6.0 Litre and Supercharged 4.0 Litre - Transmission Management

Inputs and Outputs

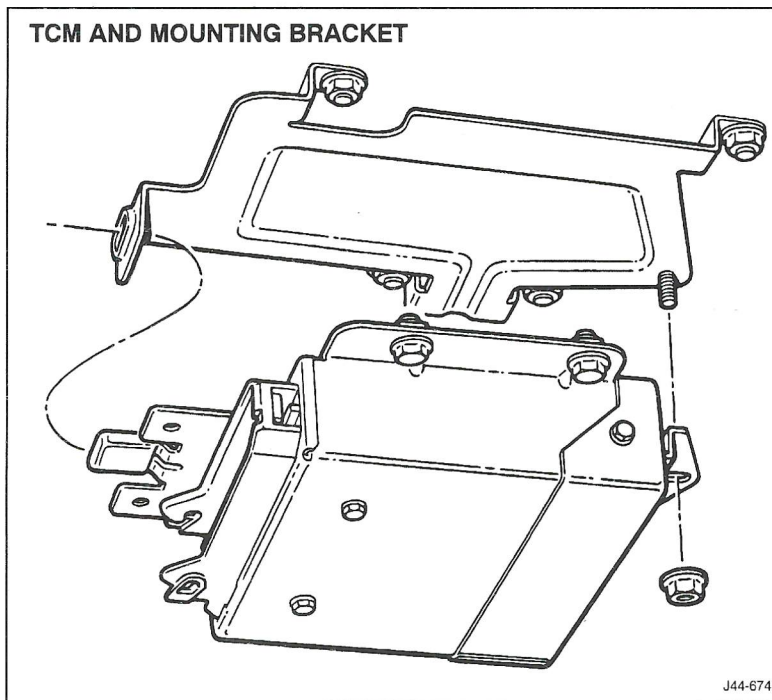
The TCM now receives an engine torque input from the engine control module (ECM), and a traction control active input from the anti-lock braking system/traction control, electronic control module (ABS/TCM). The barometric pressure, air temperature, air conditioning clutch active and one of two calibration select inputs are deleted.

On 6.0 litre models, there is a road speed output for the ECM.
